MUNICIPAL SERVICES DEPARTMENT

Date: 11/13/25 City Project No.: 25-051 Addendum No.: 1

PROJECT TITLE: El Paseo Sanitary Sewer Main Replacement

PROJECT NUMBER: 25-051

SHEET: 4 OF 6

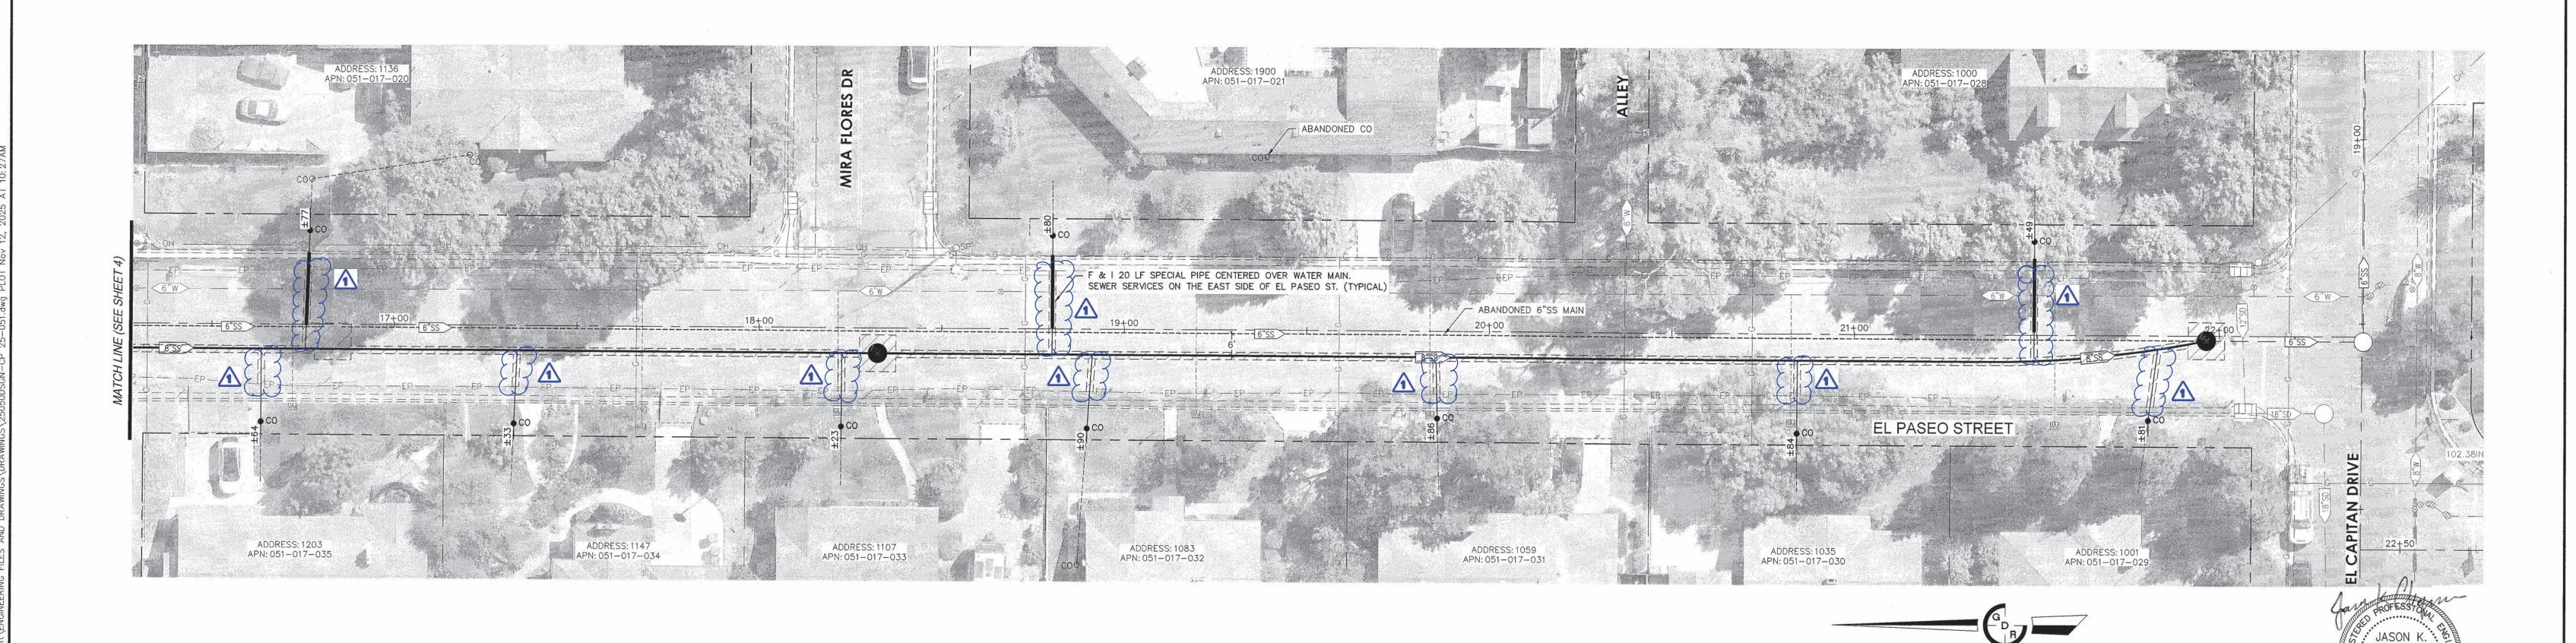
E-MAIL: GDRENGINEERING@GDRENGR.COM ADDENDUM 1 - ADDED SS LATERAL TRENCH PATCH CITY OF TURLOCK - CP 25-051 EL PASEO SANITARY SEWER MAIN REPLACEMENT EL PASEO STREET PLAN AND PROFILE SCALE: AS NOTED DATE: 11/12/2025 VG NO. 25050DSGN-CP 25-051.dwg LAYOUT 4-PP
